CHANGE ORDER REQUEST

PROJECT NAME: Barth Athletics Complex
HMS Phase IIIA

SCMC C.O.R. #: 8
DATE: 5/8/2019

Furnish and supply labor and materials to reconfigure ductwork for AC-4A
Per RFI # 08 response

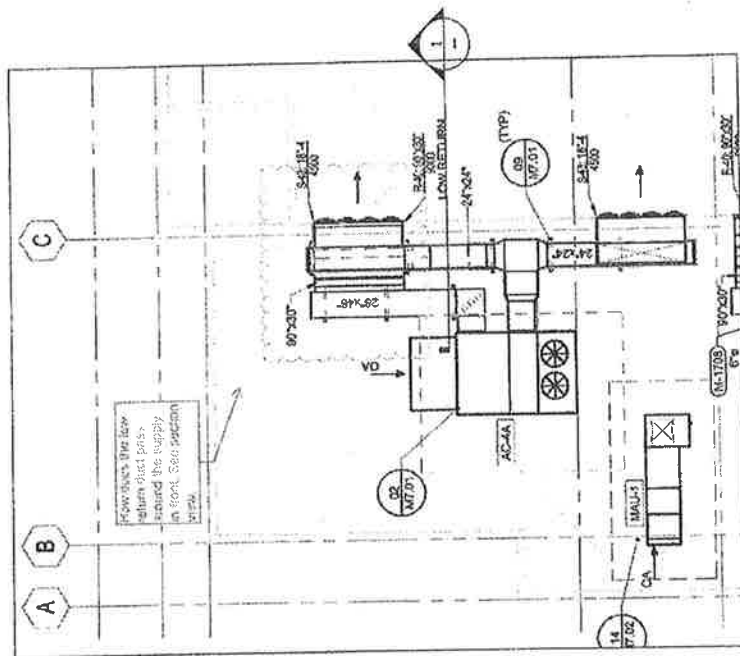
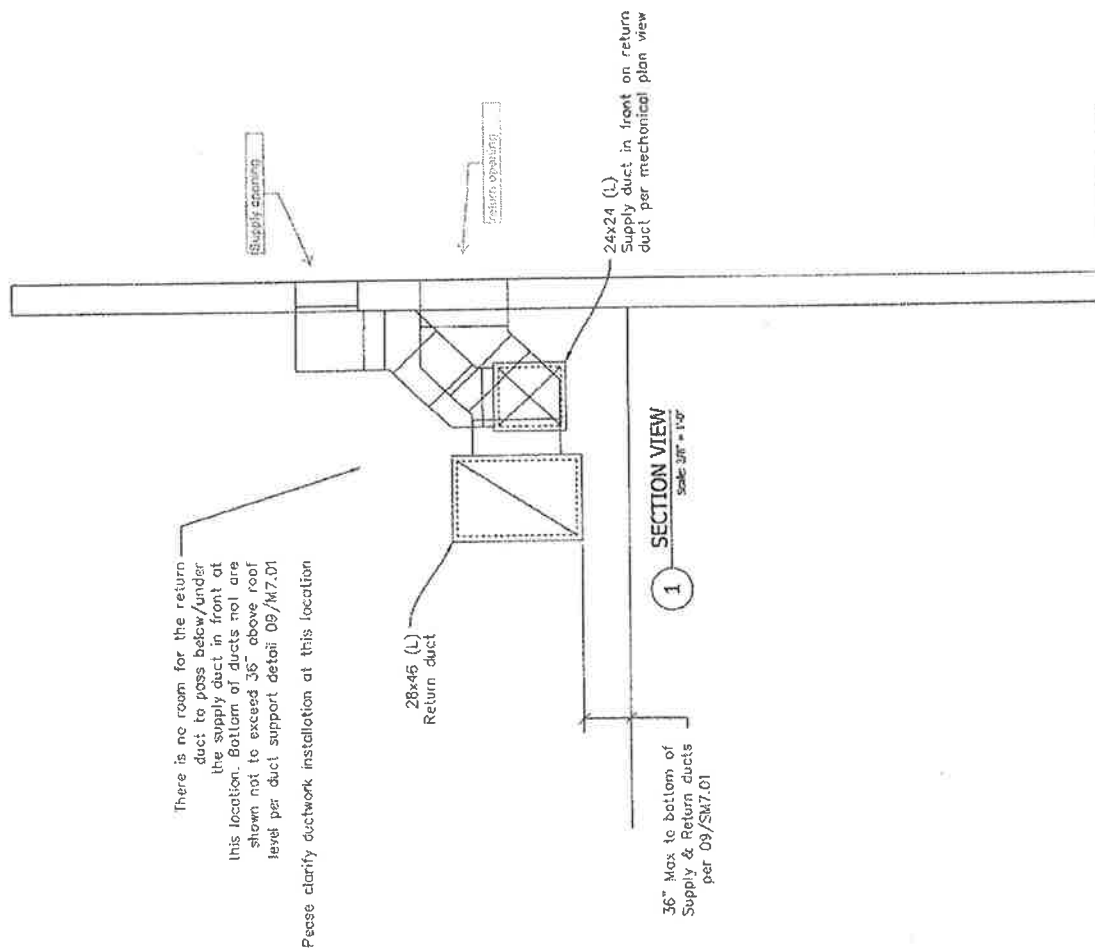
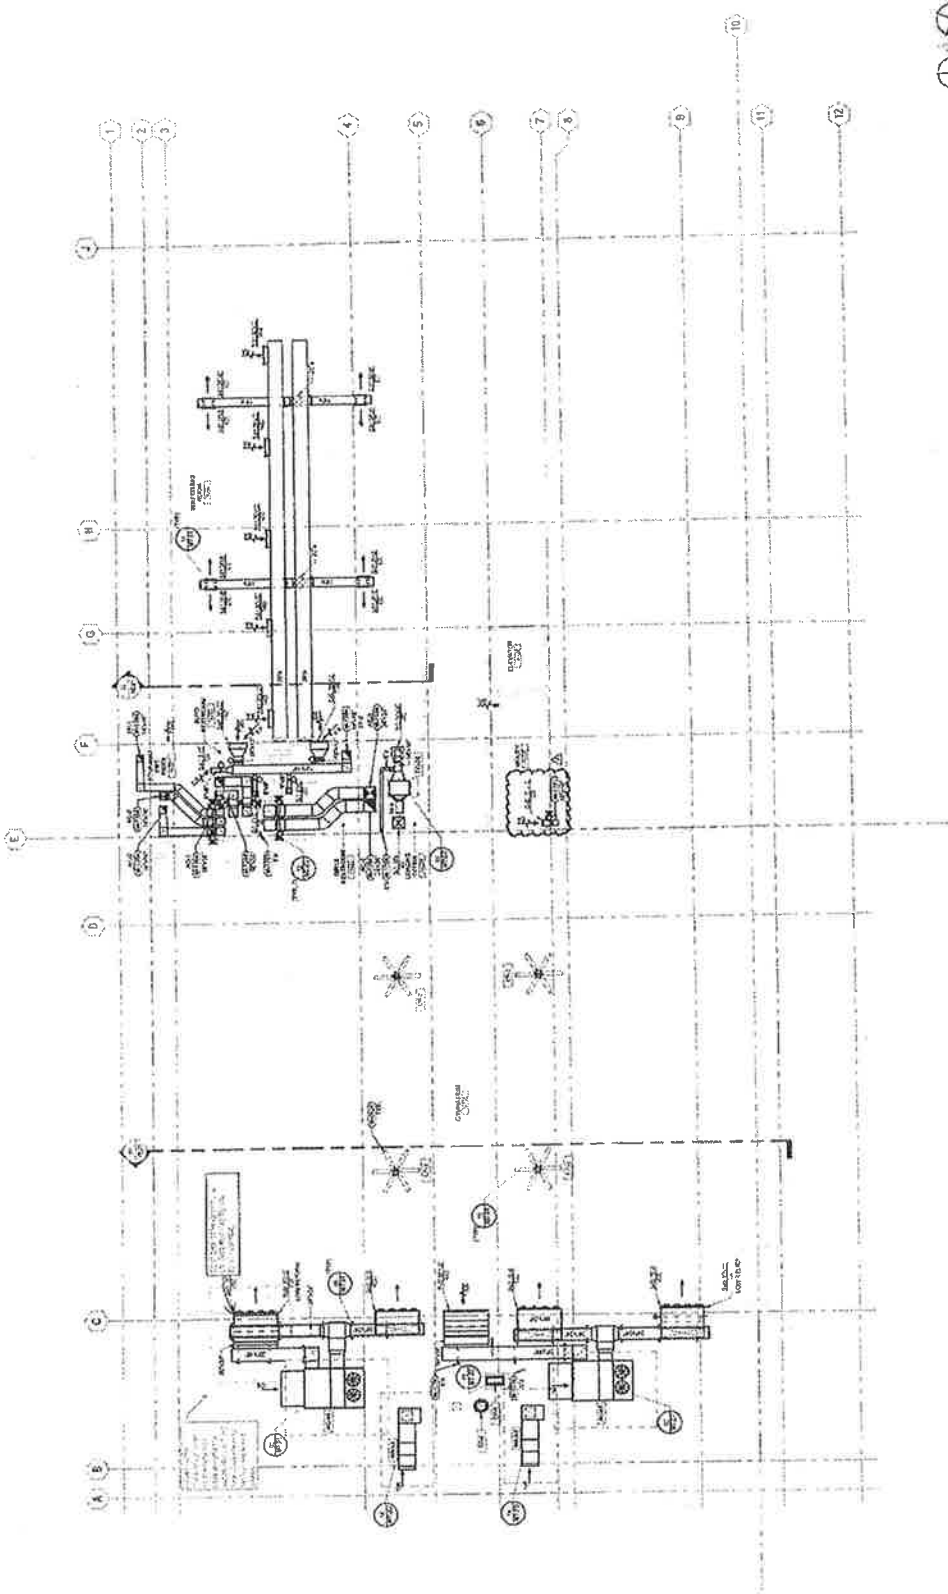
AC-4A supply and return ducts penetrate gymnasium wall at column C between grids 3&4.

The return duct is shown to route under the supply duct.

See attached section view that there is insufficient room for return duct to pass around the supply which runs in front. Both the supply and return duct plenums are shown not to exceed 36" from roof level per 09/M7.01

Please review and clarify duct installation at this location.

Please see attached revised floor plan (page 5) showing supply ductwork reconfigured to rise vertically above return ductwork. Vertical ductwork to be supported per detail 17 included in RFI #06 (page 5). See sketch on page 6 for 3D isometric of duct routing and detail for duct support from masonry exterior wall. No additional roof mounted duct supports are required.

DUCT SUPPORT FROM EXTERIOR WALL

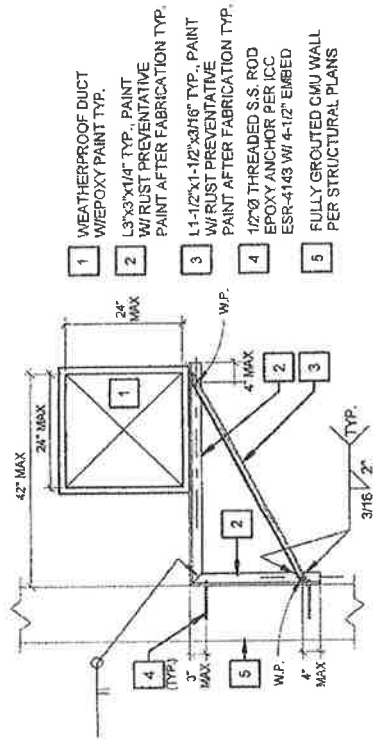
Per RFI No.: 08 response contractor should reconfigure supply ductwork at AC-4A to rise vertically above return ductwork. Contractor to support ductwork from wall per duct support from exterior wall detail 1/-

2b. Response: Original supply ductwork is still required. Cost is for addition of vertical supply ductwork to rise above return ductwork, 90 elbow fittings and wall supports shown on detail 1 of RFI sketch.

- 1 WEATHERPROOF DUCT W/ EPOXY PAINT TYP.
- 2 L3"x3"x1/4" TYP., PAINT W/ RUST PREVENTATIVE PAINT AFTER FABRICATION TYP.
- 3 L1-1/2"x1-1/2"x3/16" TYP., PAINT W/ RUST PREVENTATIVE PAINT AFTER FABRICATION TYP.
- 4 1/2" Ø THREADED S.S. ROD EPOXY ANCHOR PER ICC ESR-4143 W/ 4-1/2" EMBED
- 5 FULLY GROUTED CHU WALL PER STRUCTURAL PLANS
